MARTIN COUNTY, FLORIDA Growth Management Department

Request for Alternative Compliance pursuant to Section 12.1.12.4., Martin County LDR

| Property | 3301 / 3305 SW Mapp Road |
| Record Number | GMD2024110014 |

Figure 3. Proposed Site Plan

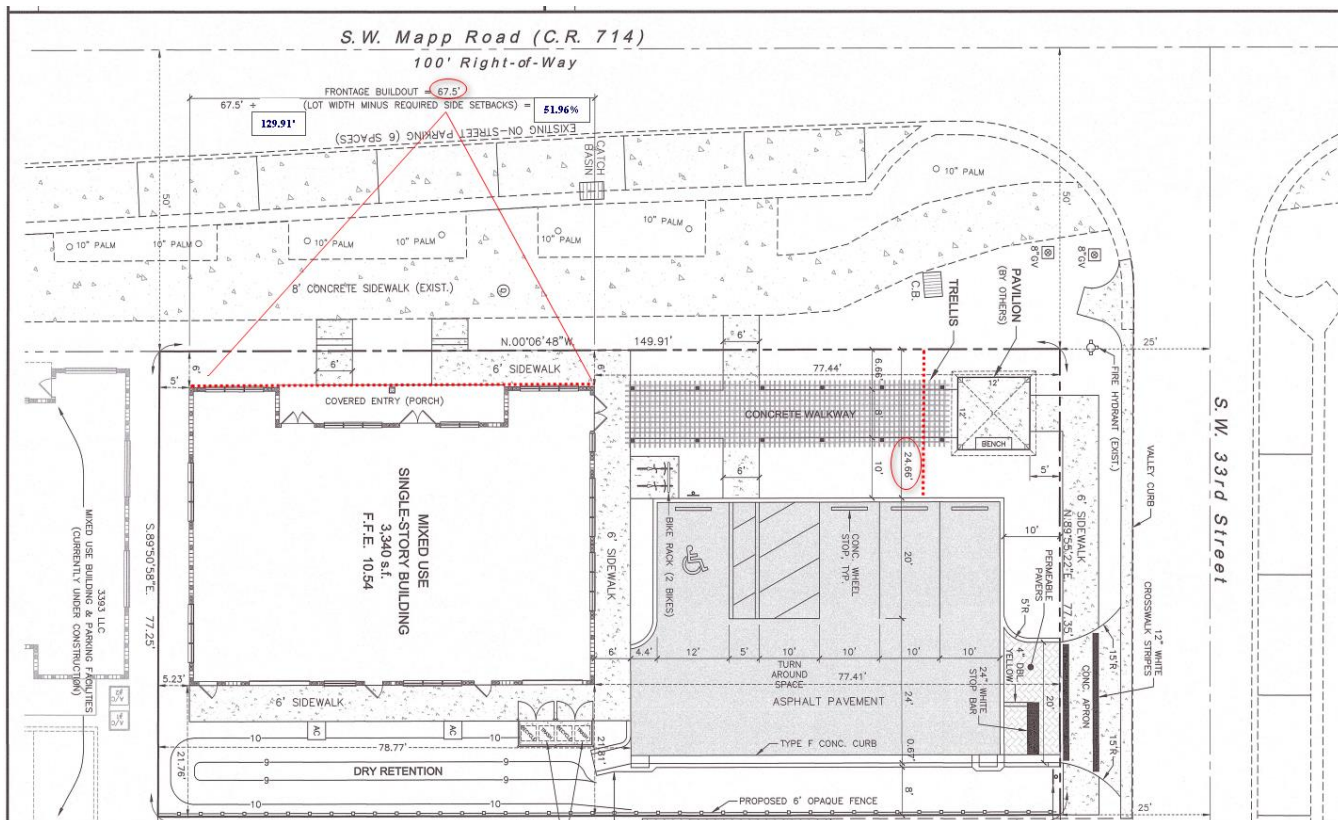
I. The applicant requests alternative compliance to: construct a new commercial building type to allow for a buildout frontage of 67.5 feet and parking placement at 24.66 feet from front property line which does not comply with:

The minimum mixed-use building type frontage buildout percentage requirement is 80% of the lot less the required setbacks. Staff asked for a minimum 8-foot landscape buffer, and the placement of the civic open space area that is part of regulations of code, of the 149.91 linear foot property minus the side setbacks of 20-feet (15ft. max side at street / 5 ft. side at property line), the required minimum building frontage is 103.93-feet. The primary building is proposed with a front façade width of 67.5-foot calculated at 51.96%. The North portion of subject parcel will contain a 54.44-foot length trellis to be constructed over an 8-foot-wide concrete walkway leading to a 12-foot-width pavilion. This is in lieu of the primary façade extending to the lot corner and yet provide the appearance of a minimum 80% building frontage requirement that would appear to meet regulations.

For the reasons set forth in this report, Growth Management staff recommends approval for this application for Alternative Compliance is order for a parking placement setback reduction from 30 feet to 24.66 feet as well as a reduction in building frontage percentage from 80% to 51.96% (67.5 feet).

Figure 5. Parking Placement

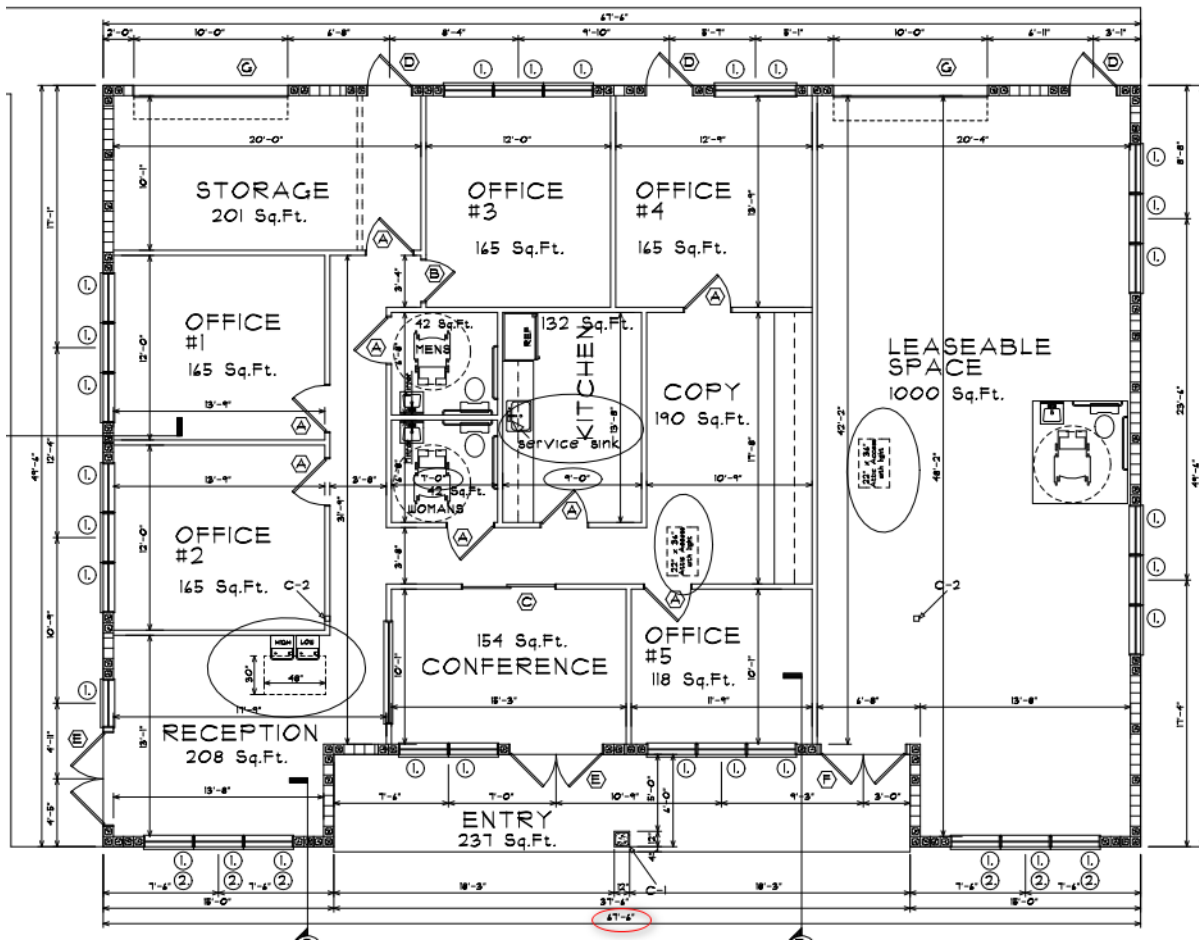
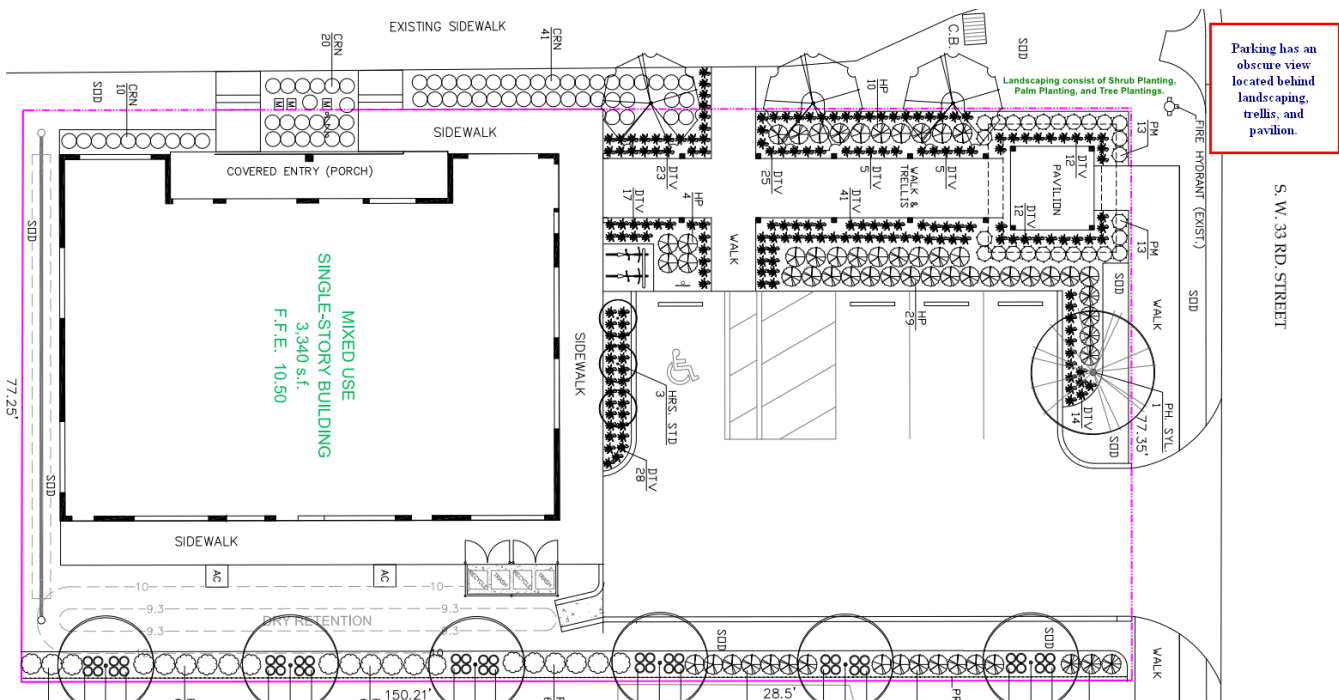
The subject parcel is 77.35-foot in width. The parking placement for the mixed-use building type is required to meet a 30-foot front setback and 10-foot side at street setback, along with meeting code requirement of parking stalls to be 20-foot by 10-foot, two-way 24-foot aisle width, and to accommodate trees and landscape to screen the vehicular use area from adjacent properties. Following feedback from staff during the initial pre-application meeting and building permit review, the north portion of subject parcel was designed for pedestrian circulation system primarily for pedestrians and only secondarily for cars that ties to adjacent commercial and mixed-use areas as well as the surrounding residential community. The site only provided 4 on-site parking stalls including a handicap stall and a 10-foot turn around space with the remaining parking provided on-street. In an effort to meet these requirements, the front parking placement setback was reduced. The placement will still meet the intent and purpose of the regulations and be compatible with other similar building-types located within the Core Subdistrict and in the adjacent neighborhood within the CRA boundary. The customer has worked with staff to create a design solution that is comparable to, but different from Article 12 standards.
